## SERVICE BULLETIN: JSB 033-1

**Subject:** Piston Circlips

**Affected Models:** Jabiru 2200 and 3300 Engines

Figure 1 – Type A (Left) & Type B (Right) Circlips<sup>1</sup>

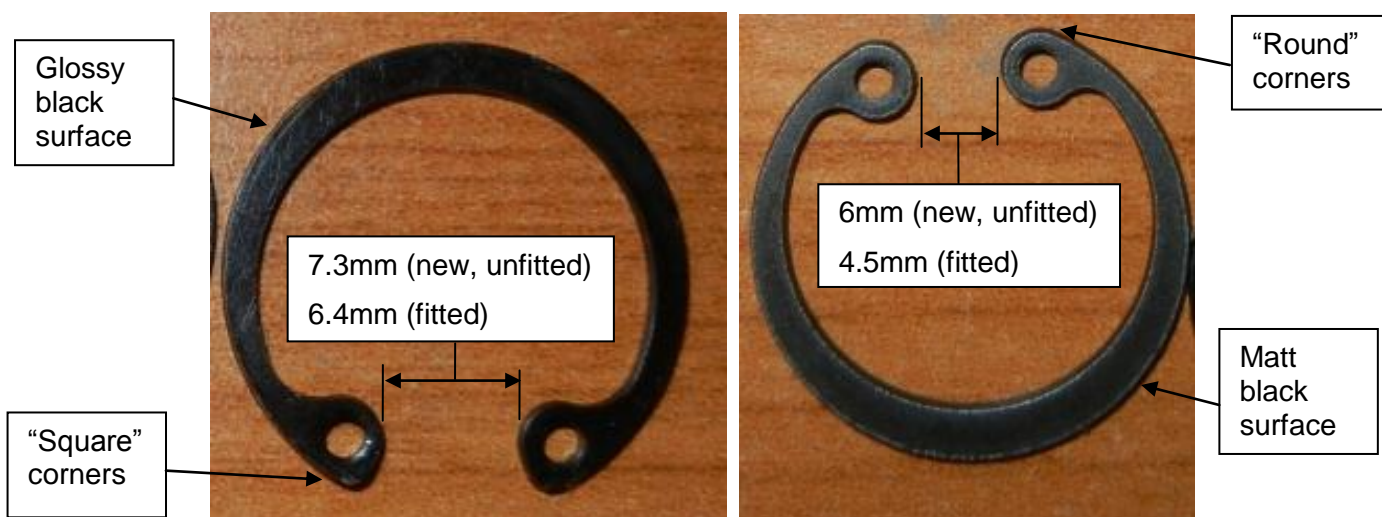
- Subsequent testing has shown that these clips are unusually sensitive to installation technique compared to clips manufactured to DIN 472. In particular, the JIS clips have a larger gap between the clip “eyes” giving greater potential for installers to over-compress and damage the clips on installation. In Figure 1 the “Type A” clip meets JIS B 2804 while the “Type B” clip meets DIN 472.

- Type B Circlip is Jabiru P/No. PH0545N.

- Disassemble the engine and replace Type A clips with new Type B parts.
- Thoroughly inspect the pistons for damage or wear to the circlip groove. If wear or damage is noted contact Jabiru Aircraft for additional guidance.
- **OR** Return the engine to Jabiru Aircraft or our local authorized representative for correction.

Figure 2 – Clip Installation Details

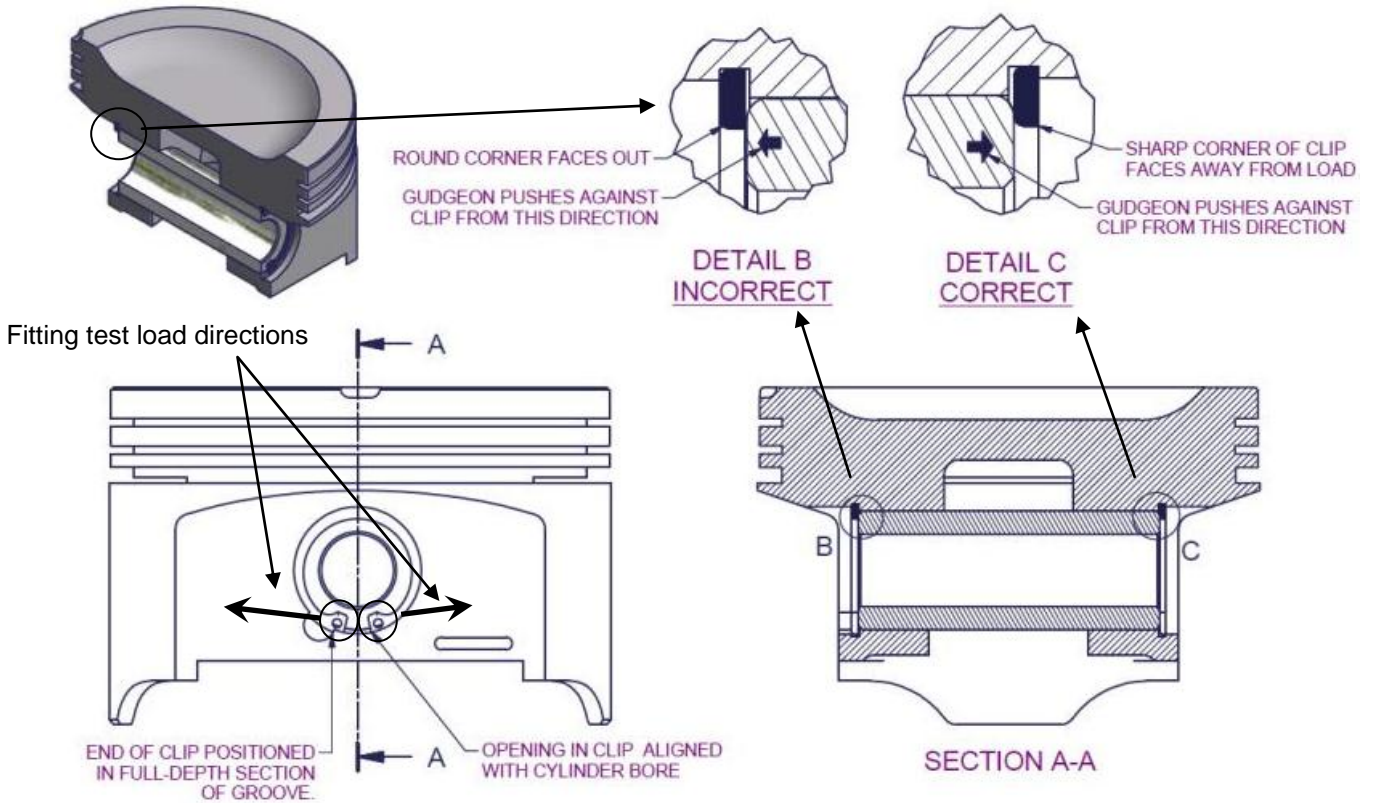
- Clips must be oriented correctly on installation: See Figure 2: the clips must be fitted with the sharp-edged corner facing outwards.
- When installing clips compress them by the minimum amount required for fitting. DO NOT compress them until the eyes of the clip touch.

- Ensure that the opening in the clip is oriented as shown in Figure 2: it must face along the axis of the barrel.
- Ensure that the ends of the clip are both positioned within full-depth sections of the groove as shown in Figure 2.

- After fitting use a small screwdriver or pick to apply pressure to the clip as shown in Figure 2: the clip should not rotate. If the clip moves, discard it and fit a replacement.

Figure 3 – Worn Circlip Grooves.

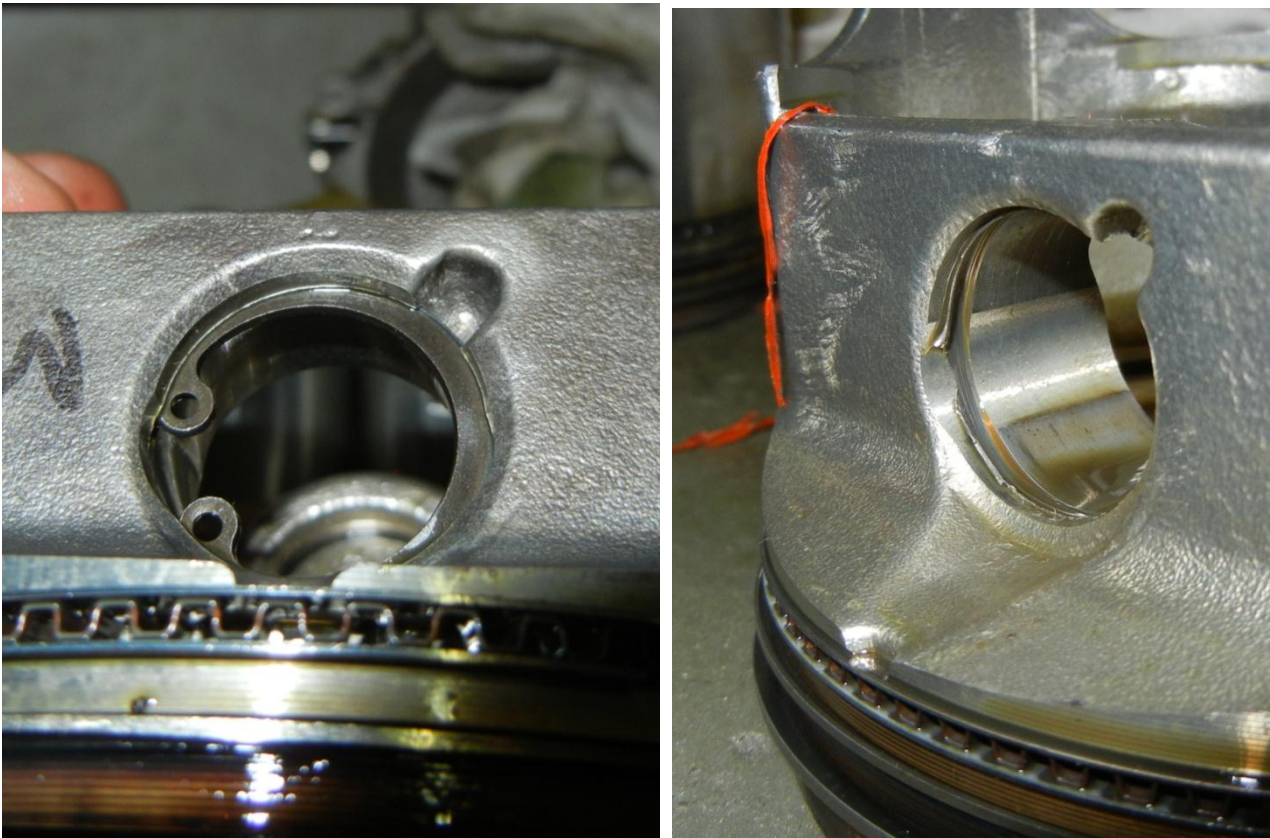
- Thoroughly inspect pistons for wear or damage before installing new clips. Figure 3 shows two pistons with worn grooves. Worn pistons must not be re-used.
